**From:** [Slovick, Mark](#)  
**To:** [Koutoufidis, Nicholas](#); [Brown, Bronwyn](#); [Smith, Ashley](#)  
**Subject:** FW: [External] Data and solar engineering report  
**Date:** Monday, August 16, 2021 9:57:06 AM  
**Attachments:** [JVR Energy Park PV syst analysis3.docx](#)

# JVR Energy Park

Preliminary Assessment of Installed Capacity as proposed by developer

Date: 8/12/2021

The following layout shows the 90 MWac project (source: Chapter 4 Project Alternative)

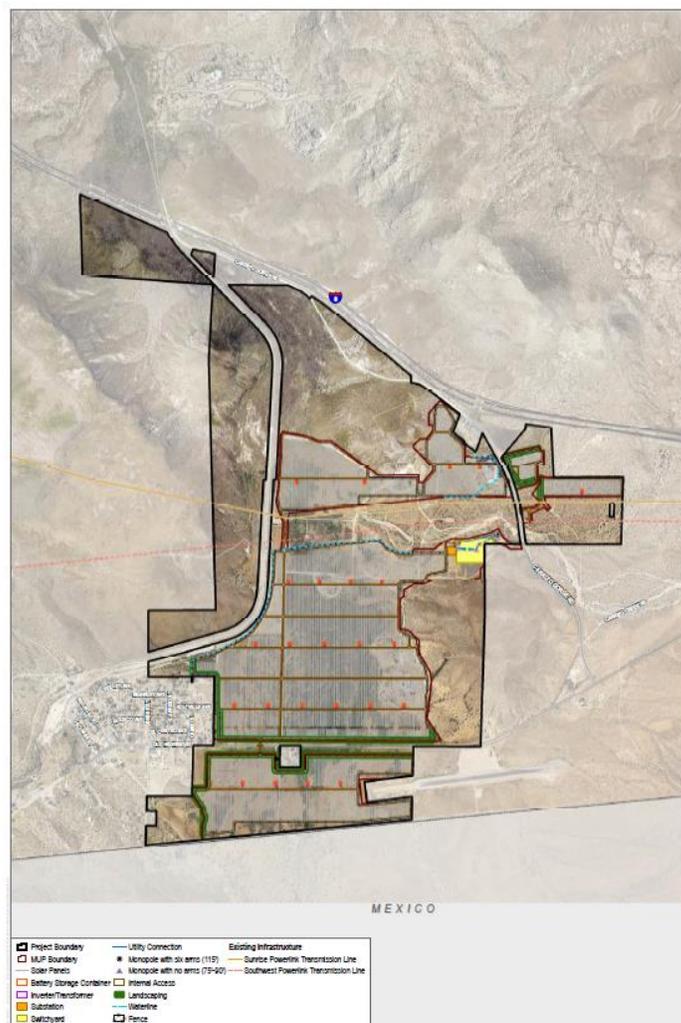
To put this into perspective, by eliminating 148 acres of panels and inverters, the entire section of the project south of Old Hwy 80 and north of the Mexico border can be eliminated. Additionally, the sections of the project along Laguna St can be pushed east by nearly 700 feet and the small section proposed behind the homes on Seeley Ave can be eliminated. The figure below shows the roughly 148 acres s of the project that could be eliminated while still meeting the fundamental project objectives of delivering 90 MW AC to the grid.

The JVR Project is a 90 MWac located at Jacumba Hot Spring, CA. the proposed project area will use 604 acres from the 24 parcels listed in the EIR.
